STATE OF MAINE

M E M O R A N D U M

RE: Response to Department Staff's Review Comments on the
Juniper Ridge Landfill Expansion Application,
MEDEP #S-020700-WD-BI-N, Transmittal Letter
Exhibit B - BGS and NEWSME'S Response to DEP's
January 15, 2016 Technical Review Memorandum,
March 2016

RE: Draft Work Plan for Refining Location of Monitoring
Wells at the Juniper Ridge Landfill Expansion Old
Town, Maine - Prepared for Bureau of General Services
and NEWSME Landfill Operations, LLC - Prepared by
Sevee & Maher Engineers, Inc. February 2016

JUNIPER RIDGE LANDFILL EXPANSION
PHASE I AND II EXPLORATIONS AND MONITORING WELLS
DEP - FIGURE 1

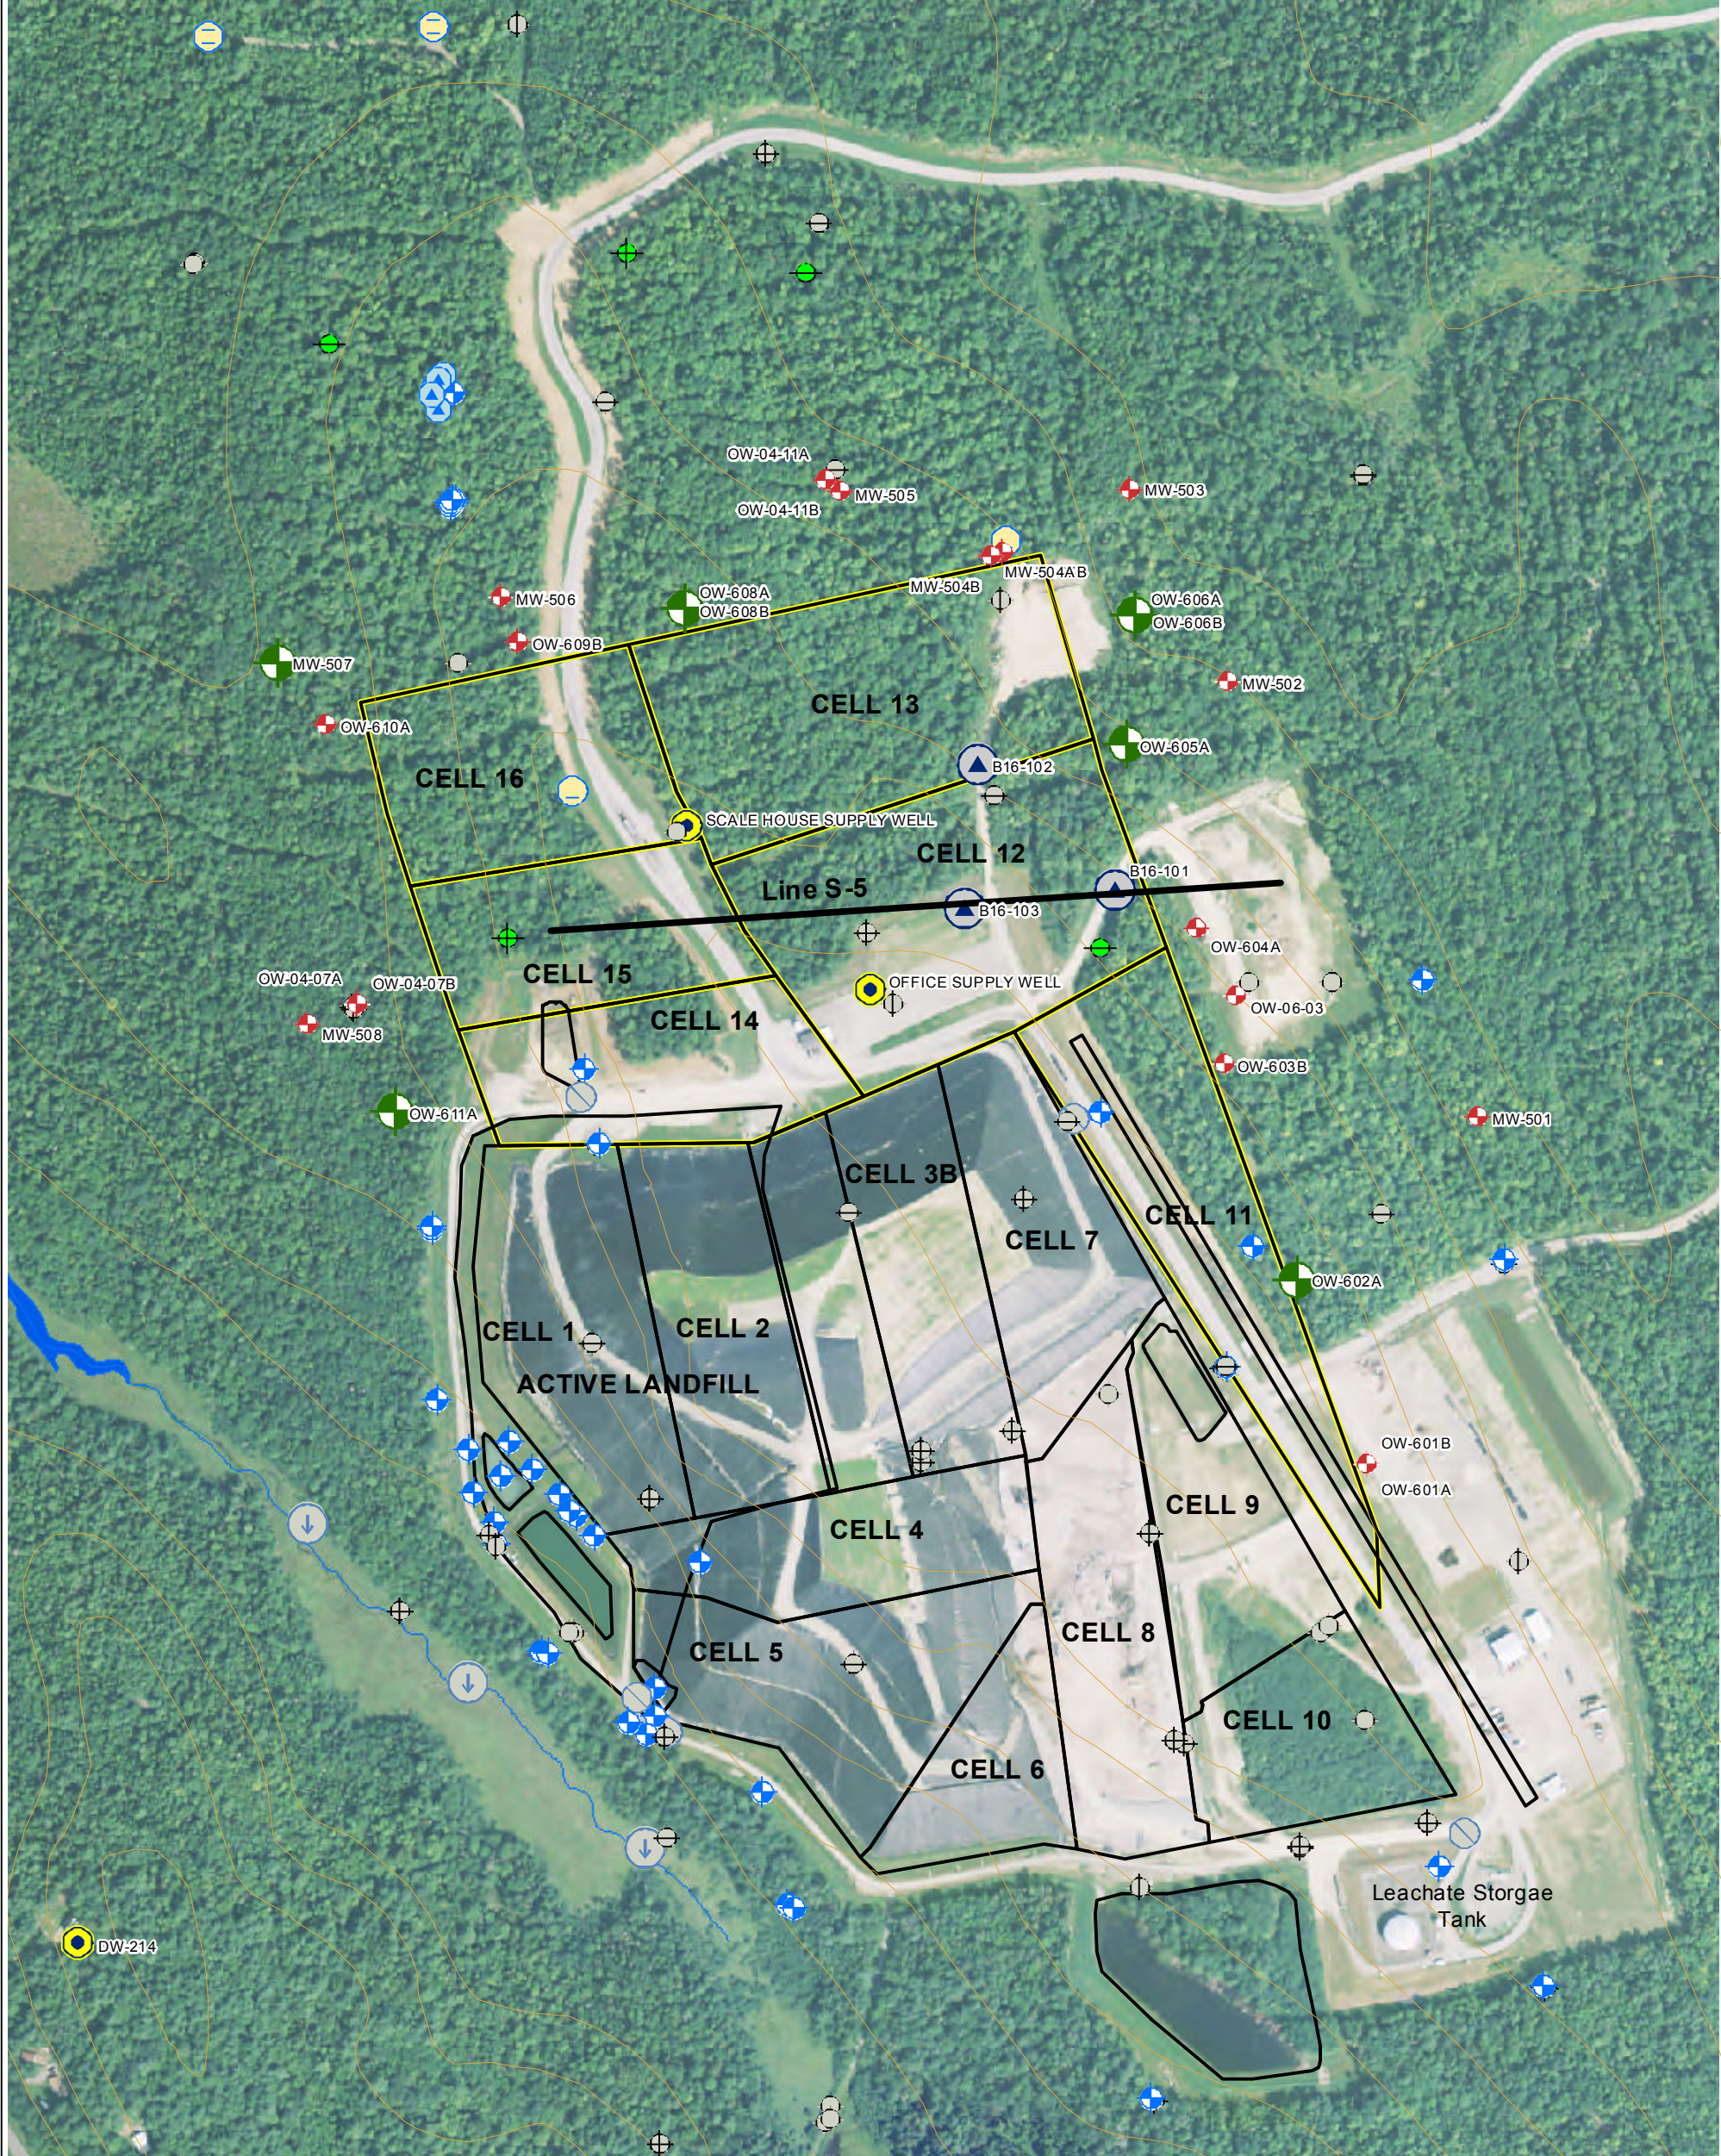
Task 5 - Electrical Earth Resistivity To help locate the bedrock explorations completed in support of the proposed expansion, JRL previously completed ten earth resistivity lines. In recognition of the utility of the method, the current work plan includes four additional geophysical lines (SME - Figure 1). To significantly improve the current proposal, I recommend one additional geophysical line. Line S-5 should be positioned roughly parallel with Line S-1 and about 250 feet due south such that it passes through two of the proposed bedrock explorations (B16-101 and B16-102). The approximate location of the proposed additional line is shown on DEP-Figure 1.

The text states Line S-3 will be located along the east side of the expansion and pass through Phase I borings. The location as depicted on SME - Figure 1 does not pass through any of the three proposed bedrock borings. SME provided the attached clarification to this discrepancy (Attachment A). The fourth line (Line S-4) will be located within the proposed expansion and according to the location depicted on SME Figure 1 its oriented northwest-southeast not north-south as described in the text. This discrepancy requires clarification.

As shown on SME Figure 1, Line S-4 will pass through the Scale House Well and the Office Supply Well. Will the existence of the steel well casings produce anomalous 2-D resistivity results?

The second paragraph of this section states, "...up to 9 individual monitoring wells and 16 individual expansion observation wells are anticipated." I have been unable to reconcile this description with the number of monitoring and observation wells depicted on SME Figure 1. I understand the Environmental Monitoring Plan for the proposed expansion includes a combination of wells designated with the prefix "MW" for monitoring wells and "OW" for observation wells. The inconsistency may arise, in part, from the nomenclature and symbology used on SME Figure 1.
